#### MEMORANDUM

Mandatory Referral No. 9709-MCPS-1:

Farmland Elementary School Modernization Project,

**SUBJECT:** Farmland Elementary School Mandatory Referral – MR # 09709-MCPS-1

# Site Layout Concept

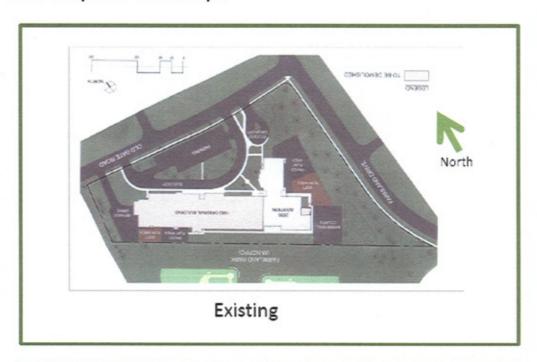
The parking lot setback from Old Gate Road, is 10 feet instead of the 30 feet required by the development standards. An evergreen hedge should be provided along the parking lot on Old Gate Drive to reduce the visual impact as required in the Zoning Ordinance. There is one tree for every 40 feet of lot frontage for the parking lot as required. With the additional evergreen hedge, staff recommends approval of the setback.

Pedestrian Circulation-The on-site sidewalk system will be connected to the existing neighborhood sidewalk and provide safe routes for pedestrians. MCPS should also provide an additional pedestrian connection from Farmland Drive to the eastern edge of the new school building to provide for more efficient access for walkers. Work with the Department of Parks to provide a connection between existing two lead-in paths from Hitching Post Lane and the school buildings/school play areas.

#### **ATTACHMENT A**

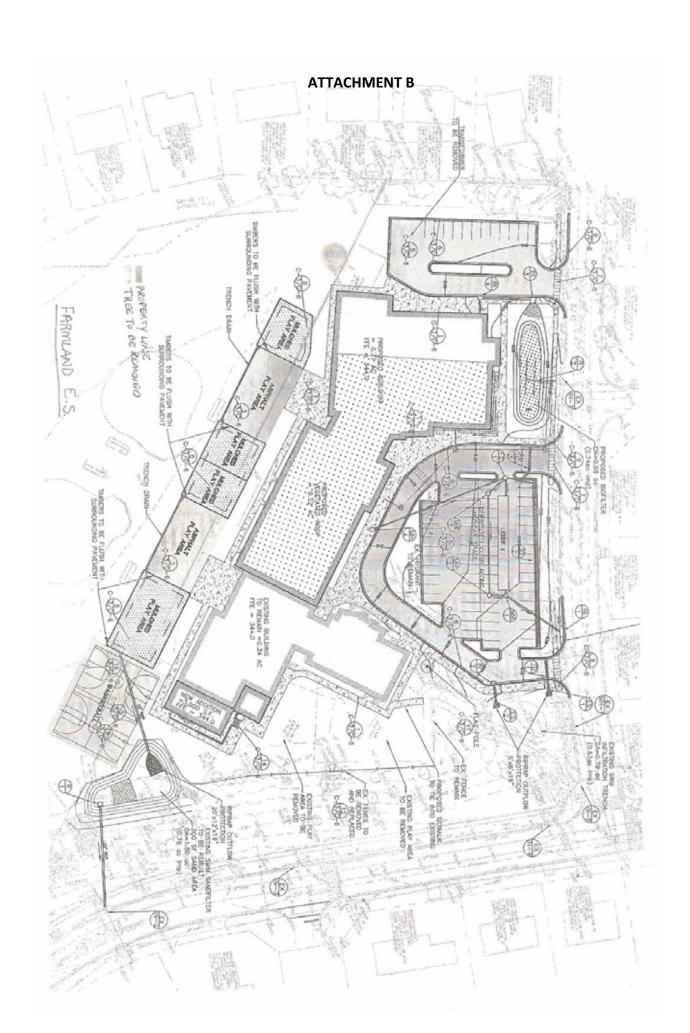
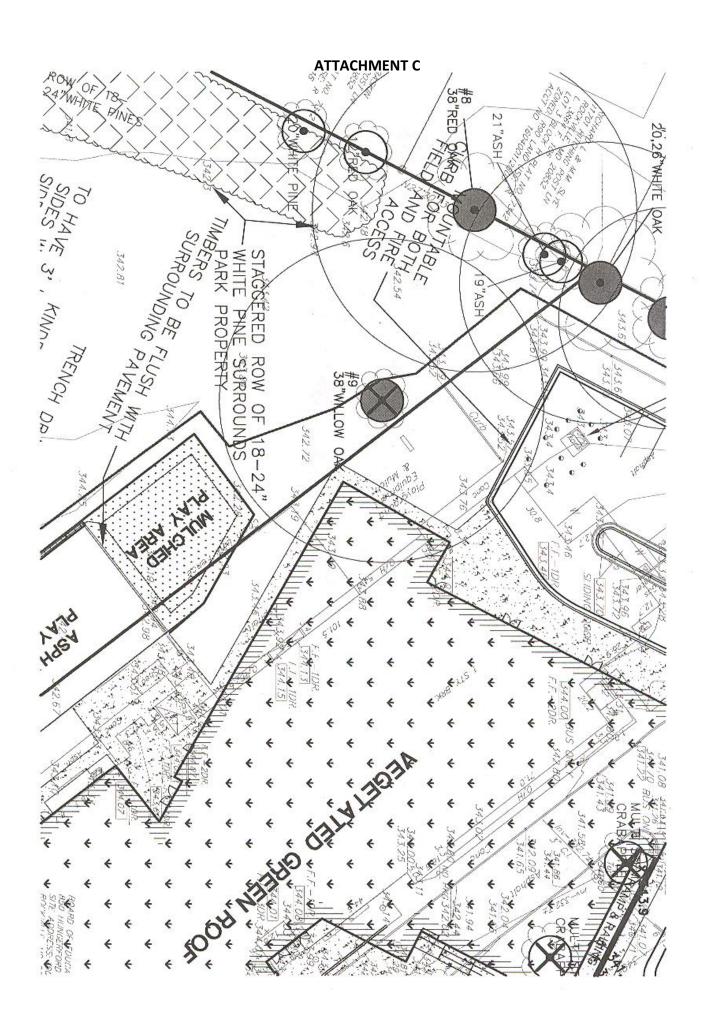
The following comments are in response to the plans illustrated in Attachments A and B:

- 1. A 1:1 inch replacement of tree shall be provided for the approved removal of the existing 38-inch Willow Oak (Attachment C) near the southwest corner of the proposed building. The standard requirement by Parks is to plant replacement trees that are 1 ½ to 3" in caliper. Species selection and location shall be approved by the Parks Staff.
- 2. To improve the safety of the playground users during baseball/softball games, the existing softball field needs to be relocated. The field shall be moved to be in alignment with the existing baseball field (Attachment D and E) thus pulling it away from the school's proposed play areas. The final design of the relocated field and associated facilities shall be reviewed and approved by the Parks staff, at the time of Park Construction Permit. All designs must comply with Department of Parks' guidelines, details, and specifications.

- 3. A new hooded backstop shall be provided for the existing baseball field and the relocated softball field. In addition, the player bench areas with benches shall be replaced and a new home plate provided for both fields. Two ten-foot-high chain link fences with foul poles shall be provided along the school side for each field. A single ten-foot-high chain link fence with foul pole shall be provided between the two fields. Any damage to the infield or outfield due to school construction shall be repaired. All designs must comply with Department of Parks' guidelines, details, and specifications

- 4. Signs shall be provided on the basketball courts and the play area next to the baseball field to warn of the potential of foul balls. Exact language will be determined by the Parks Staff.

- 10. MCPS shall provide a permanent secured and stripped entrance for park maintenance vehicles and equipment. The entrance shall be shown on the Park Construction Permit plans.
